July 1, 2021

ADDENDUM No. 1

Oregon Central Fire Station

G8.5
A8.5
SIGN DISPLAY PLAN
SCALE: 1/2"=1'-0"

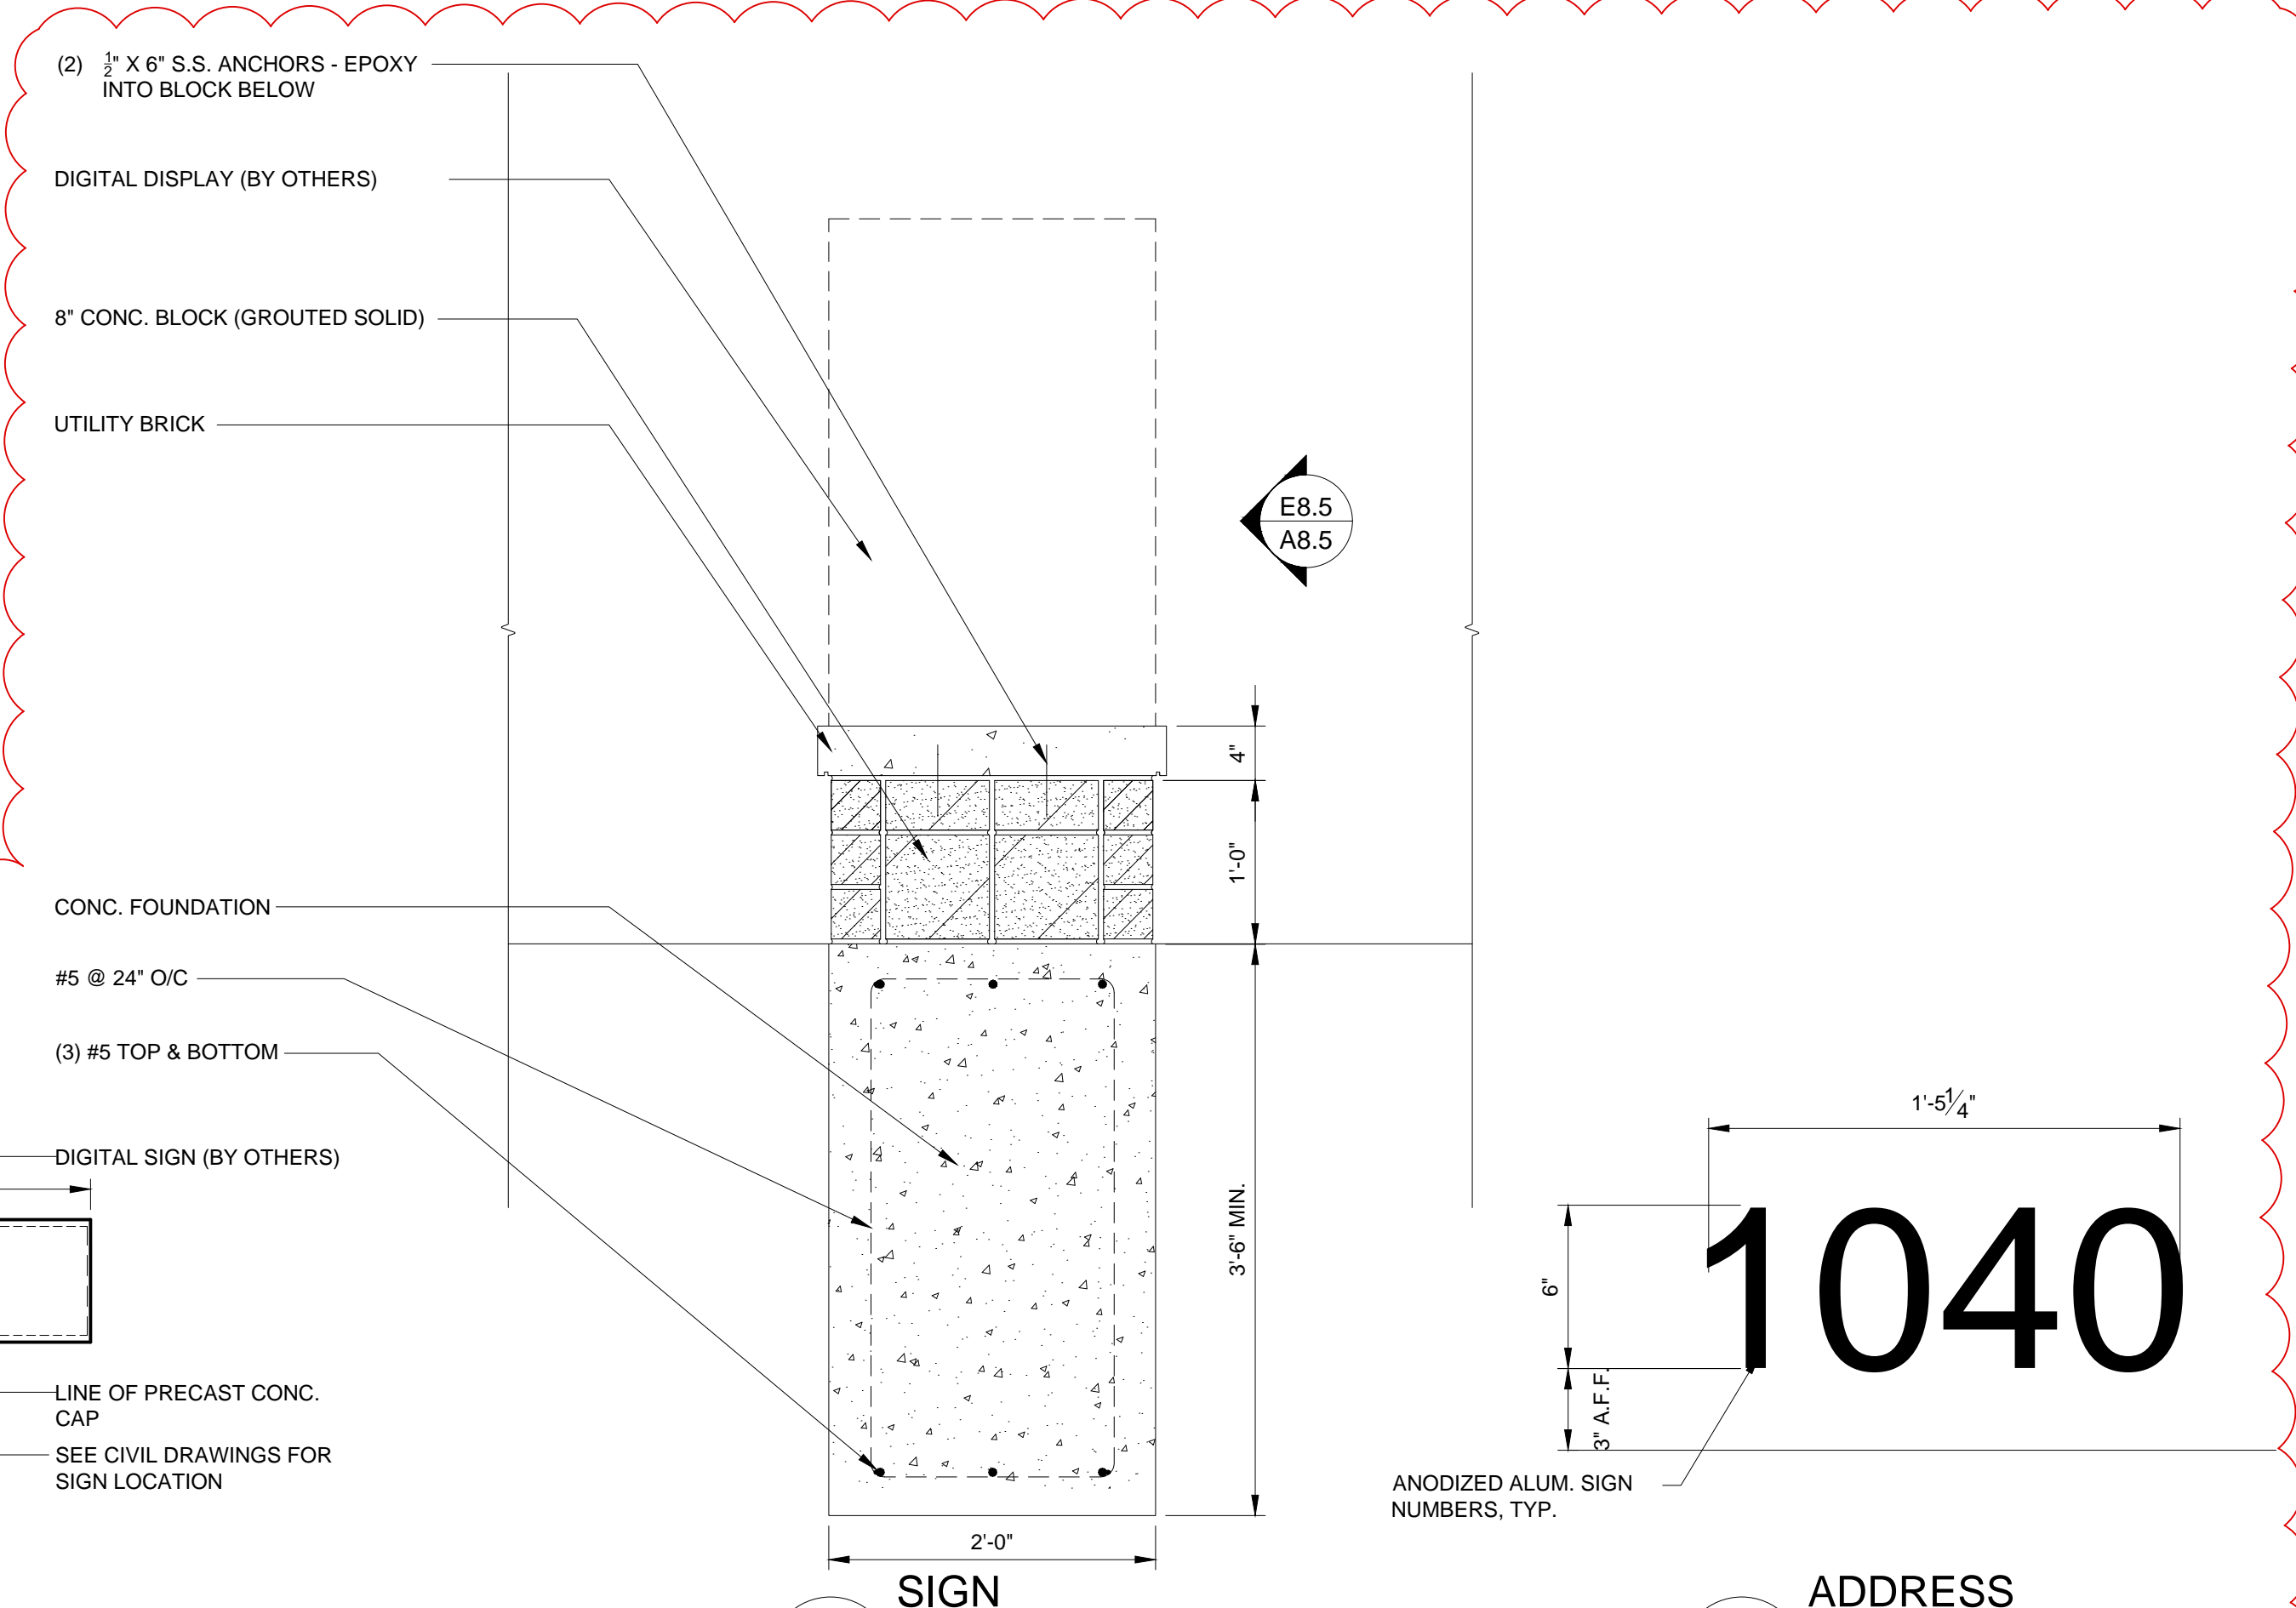
- See attached revised drawing A8.5 for revised digital sign details.
